GULF STATES UTILITIES COMPANY

May 22, 1985
RBG - 21090
File Code: G9.5

River Bend Station - Unit 1
Docket No. 50-458

Provided for your information are Gulf States Utilities Company (GSU) Final Safety Analysis Report (FSAR) changes that were identified during GSU's indepth review of the River Bend Station Technical Specifications. These changes are provided to ensure consistency between the Technical Specifications and the FSAR.

Figure 4.3-1 RIVER BEND STATION – FSAR INITIAL CORE LOADING MAP

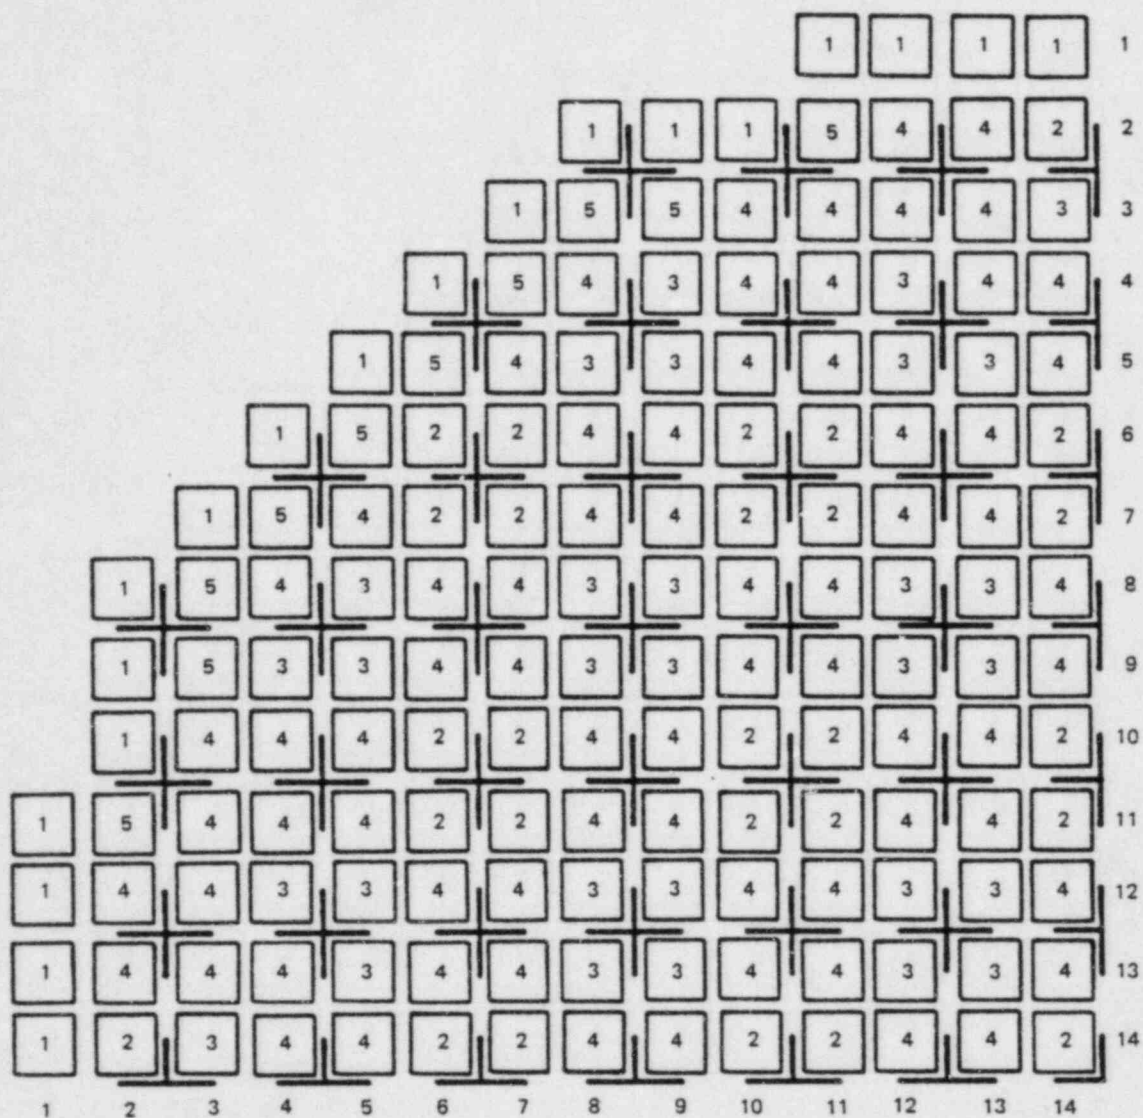
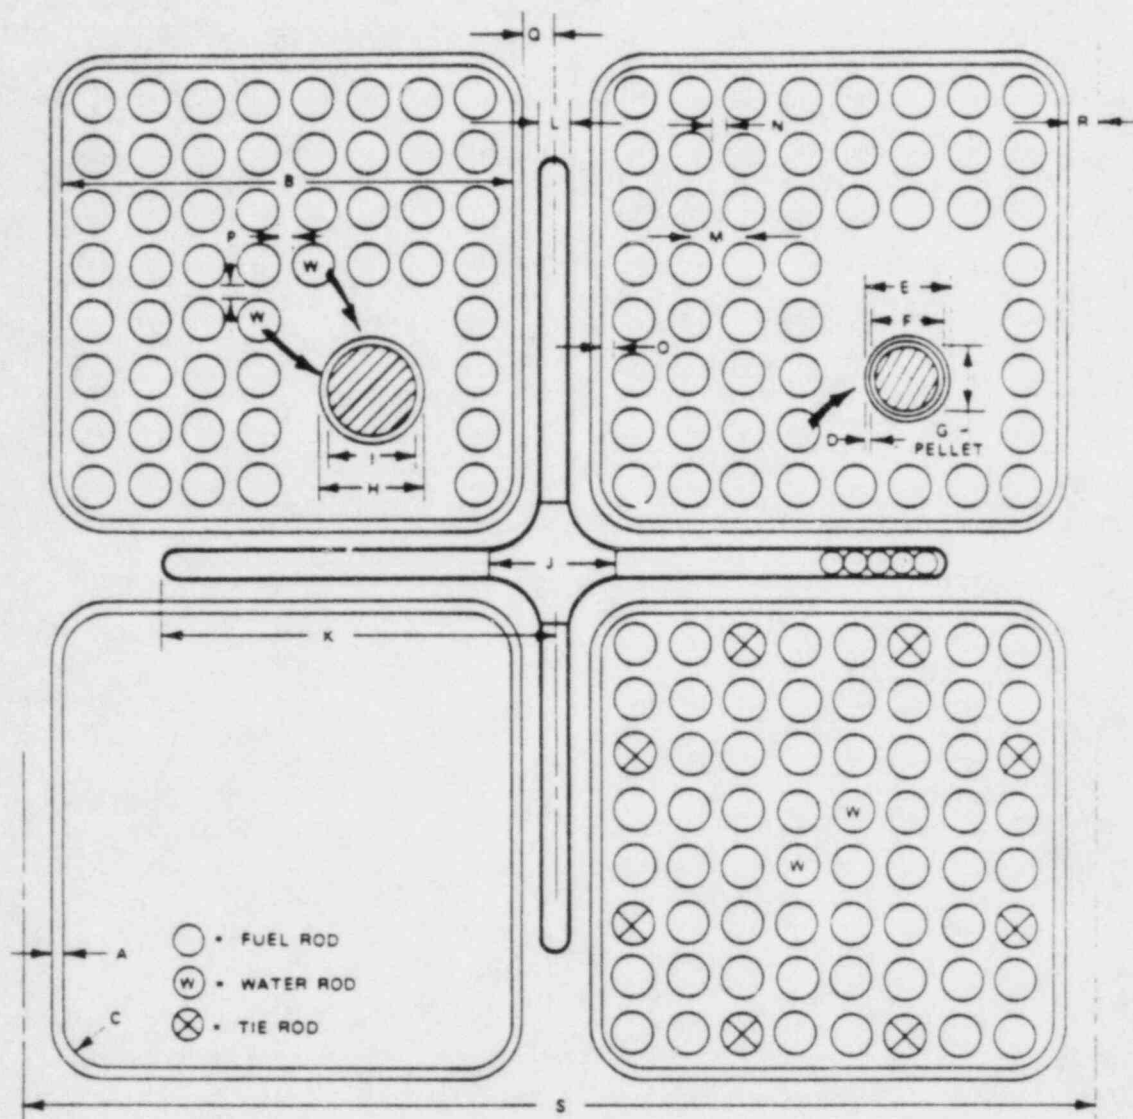
The River Bend initial core contains five fuel assembly types which are arranged in the loading pattern shown in Fig. 4.3-1.

Replace with
attached

BUNDLE TYPE	NUMBER OF BUNDLES	BUNDLE AVG. ENRICHMENT
1 P8SRB071	76	0.711
2 P8SRB094	108	0.94
3 P8SRB163	120	1.63
4 P8SRB248	280	2.48
5 P8SRB278	40	2.78

Figure 4.3-5 RIVER BEND STATION - FSAR
K-INFINITY AS A FUNCTION AT VARIOUS
VOID FRACTIONS, UNCONTROLLED,
TYPICAL FUEL TYPE

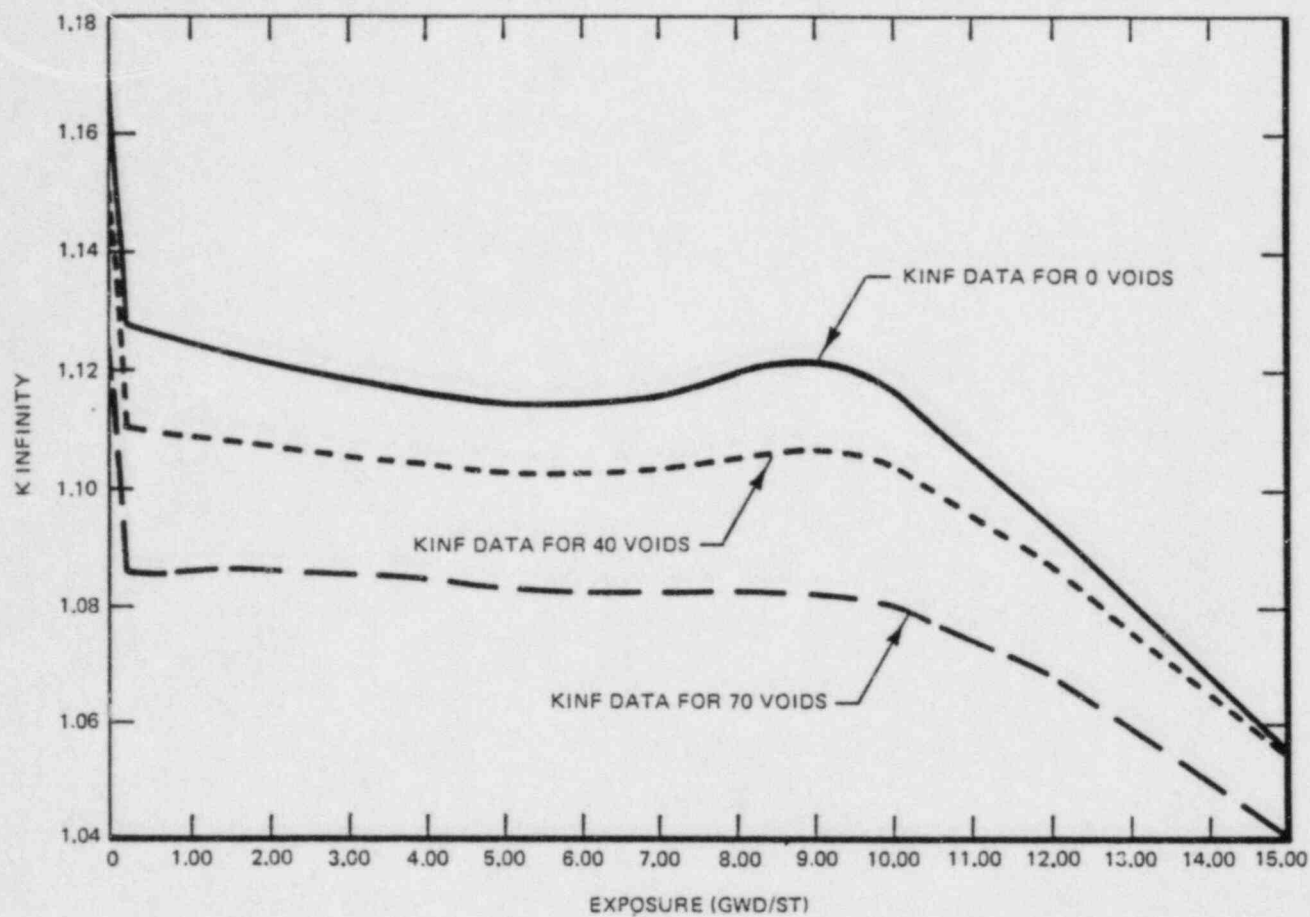
Replace

Figure 4.3-6 RIVER BEND STATION - FSAR
WEIGHT FRACTION AS A FUNCTION OF
EXPOSURE, 40% VOIDS FOR THE TYPICAL
FUEL TYPE

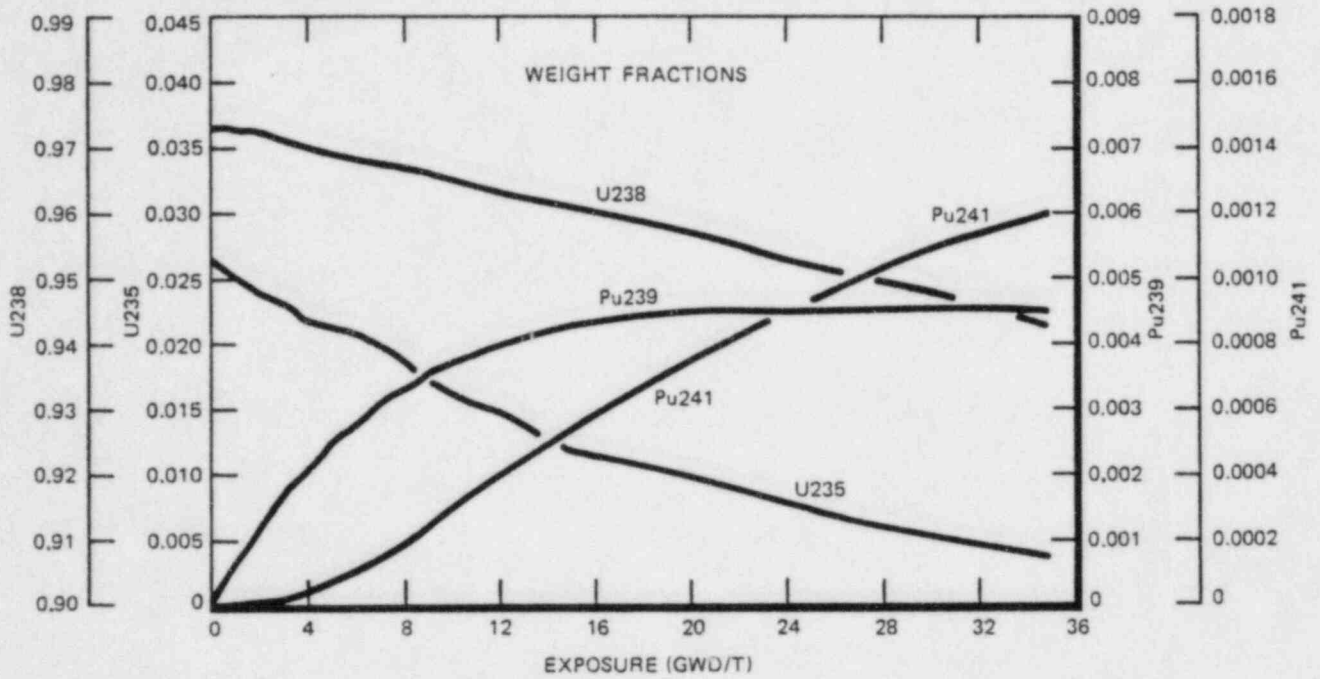
The bundle reactivity is a complex function of several important physical properties. The important properties consist of the average bundle enrichment, the gadolinia rod location and gadolinia concentration, the void fraction, and the accumulated exposure. The variation in reactivity of the infinite lattice data (k -infinity as a function of void fraction and exposure) for the dominant gadolinia segment of the typical enrichment bundle is presented in Fig. 4.3-5. The isotopic concentrations as a function of exposure for the typical bundle, dominant fuel type, are presented in Fig. 4.3-6 for the important heavy element isotopes.

Replace

Figure 4.3-7 RIVER BEND STATION – FSAR
FISSION FRACTION AS A FUNCTION OF
EXPOSURE, 40% VOIDS FOR THE TYPICAL
FUEL TYPE

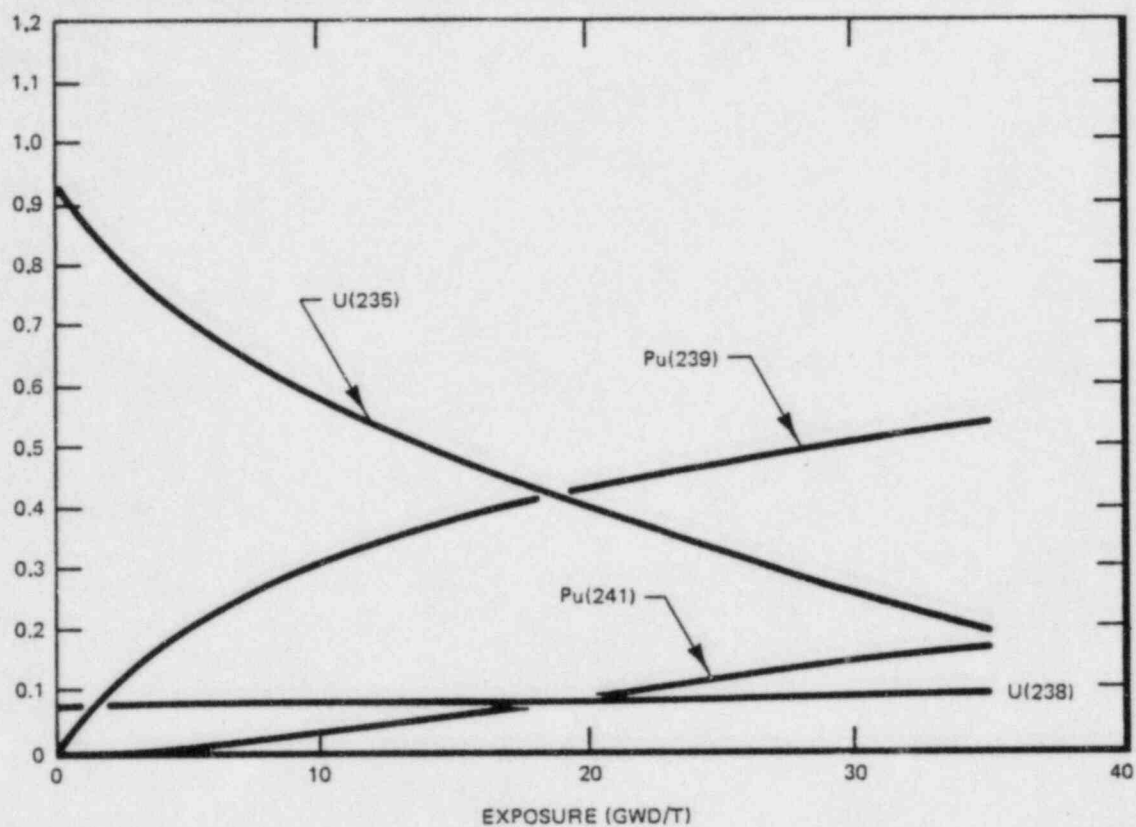
isotopes is shown in Fig. 4.3-7 for the typical bundle, dominant fuel type. Data and discussion concerning plutonium buildup are presented in Reference 5.

Replace

Figure 4.3-8 RIVER BEND STATION – FSAR
DELAYED NEUTRON FRACTION AS A
FUNCTION OF EXPOSURE AT 40% VOIDS,
TYPICAL FUEL TYPE

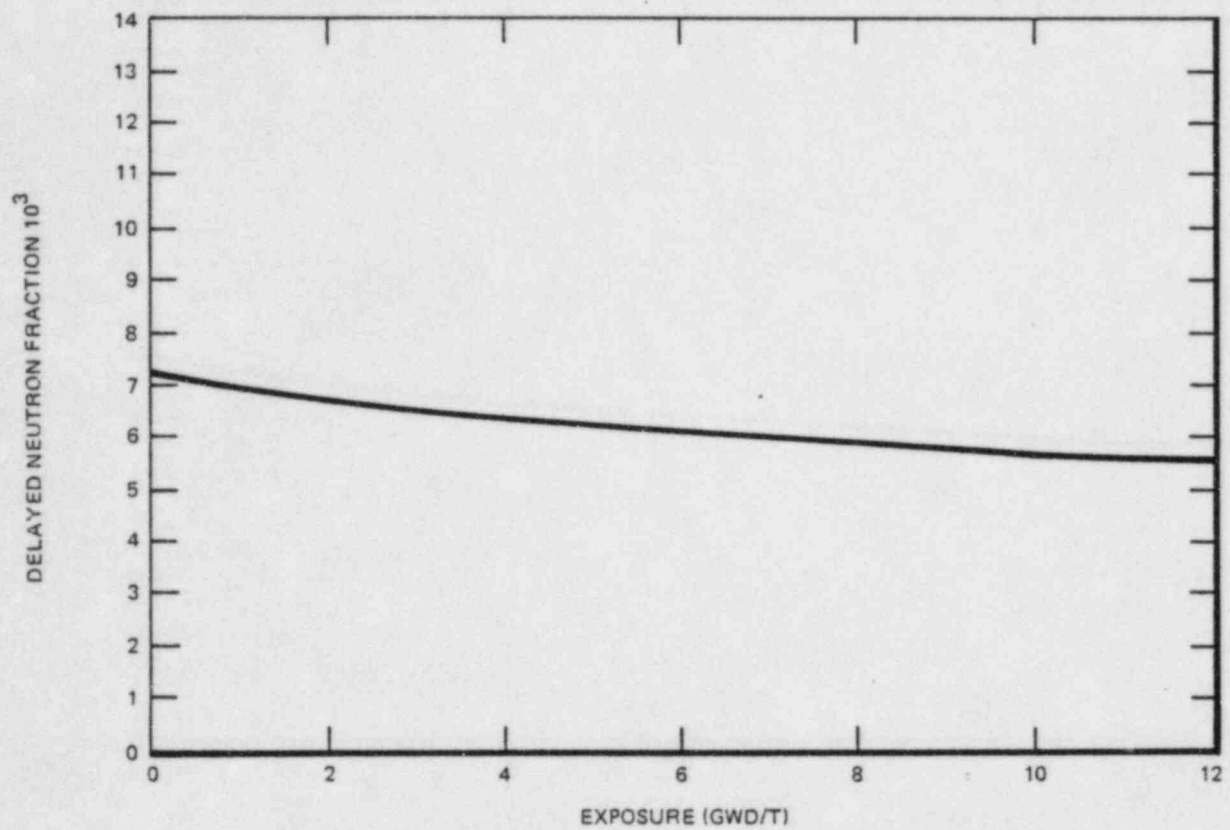
Delayed neutron fraction as a function of exposure at core average voids is shown in Fig. 4.3-8.

Replace

Figure 4.3-14 RIVER BEND STATION – FSAR
FIRST CYCLE MODERATOR VOID
COEFFICIENT (FOR STABILITY ANALYSIS)
AS A FUNCTION OF VOIDS

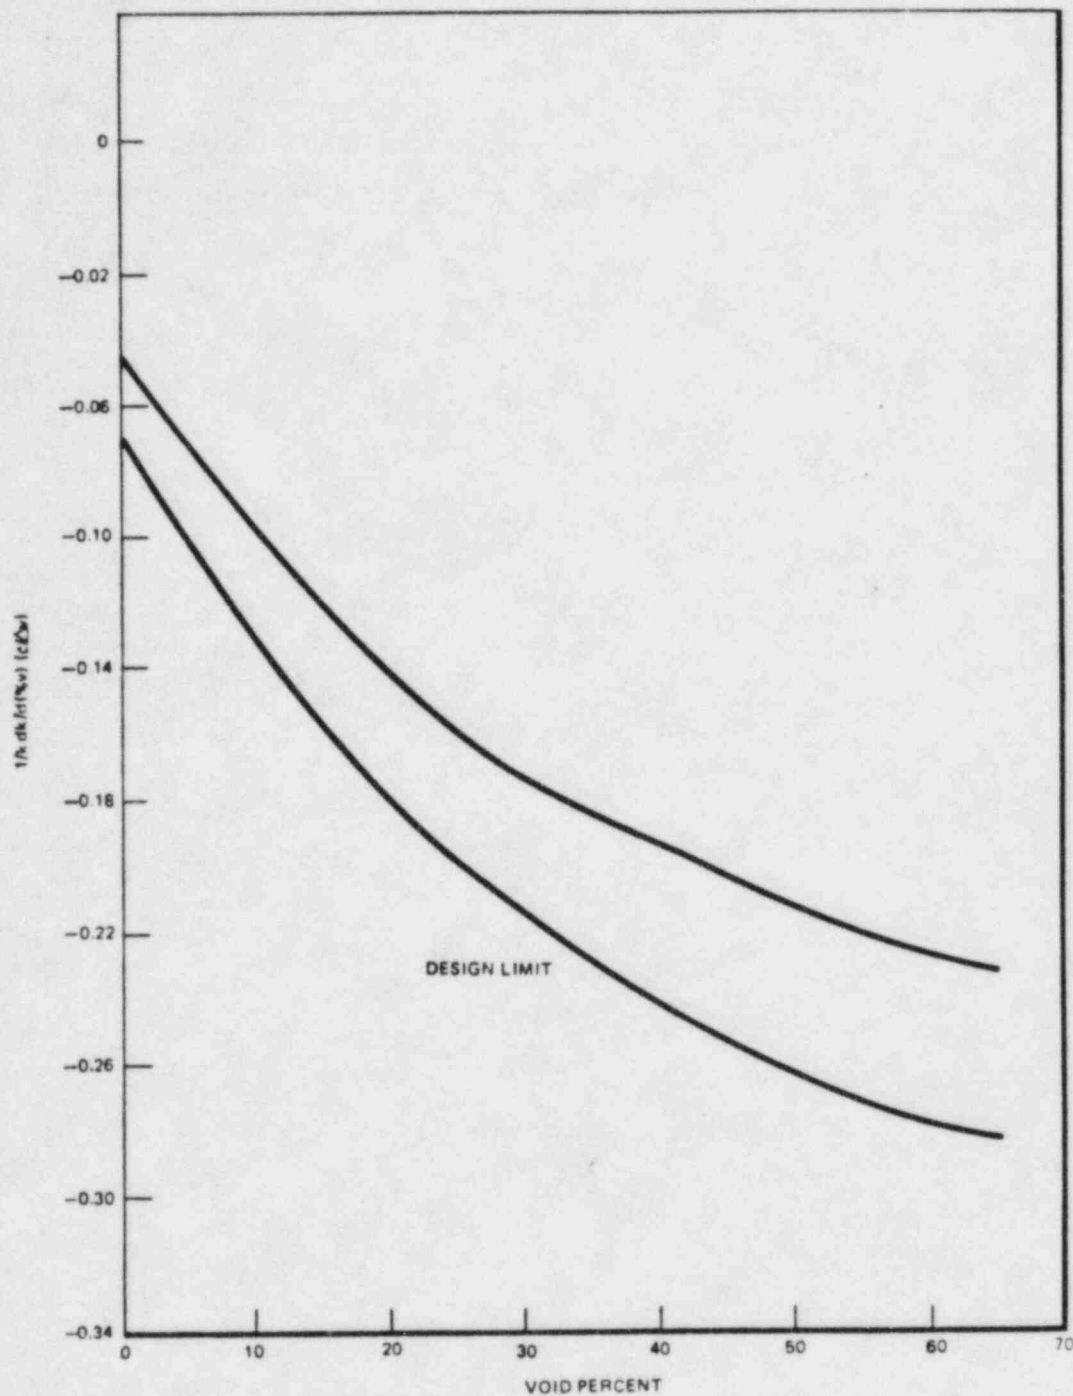
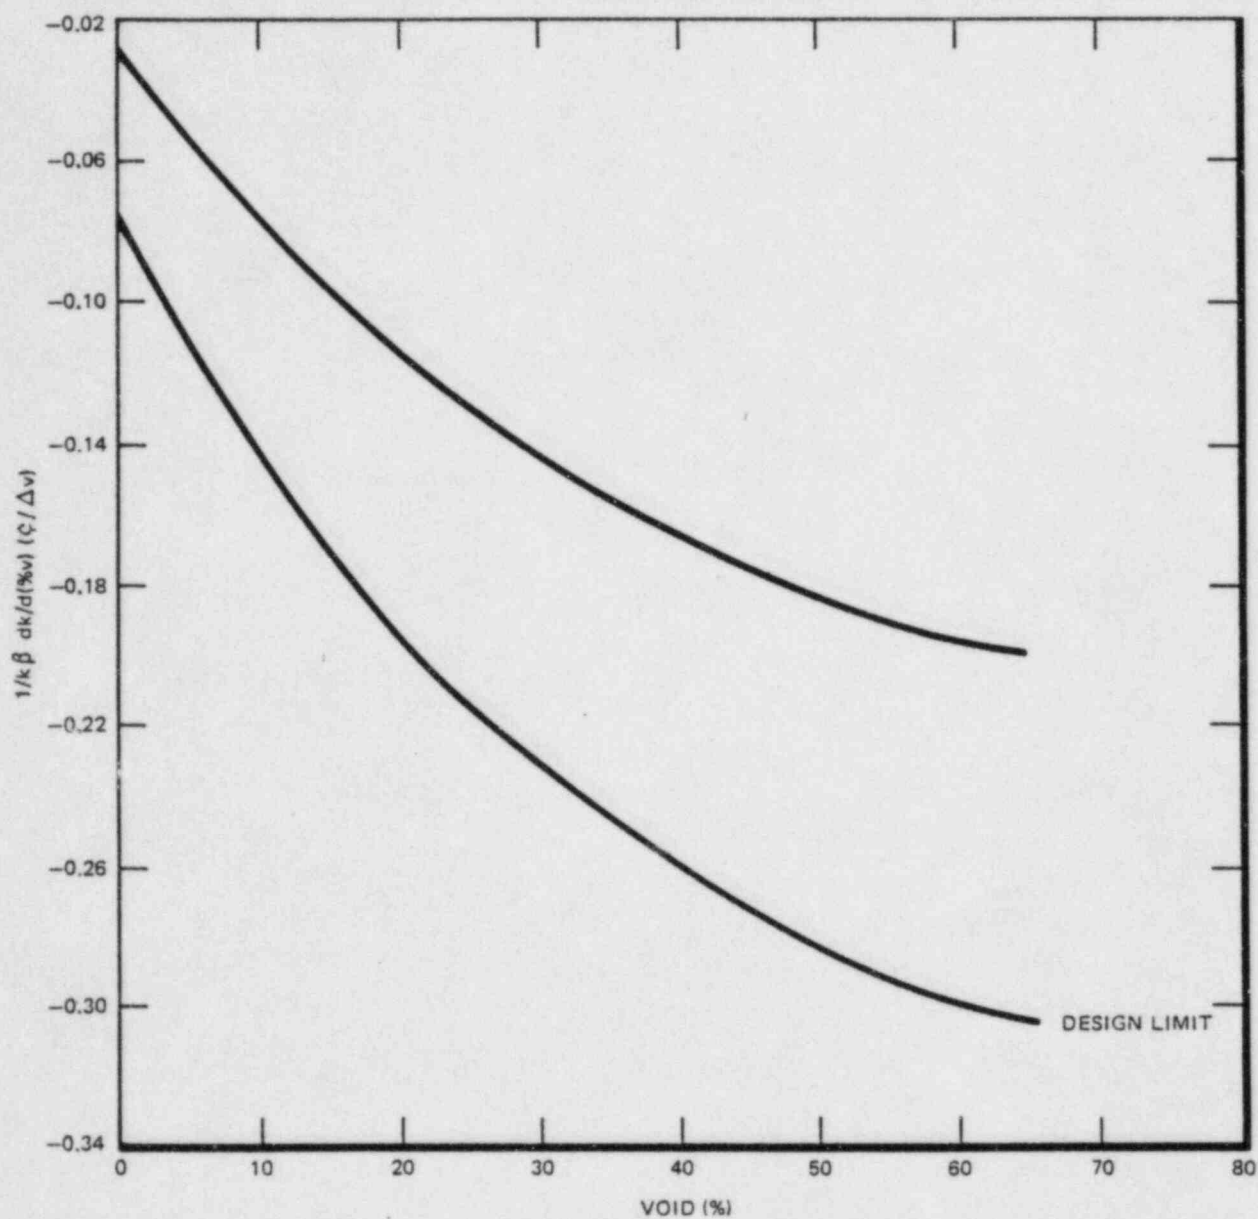
Replace with
attached
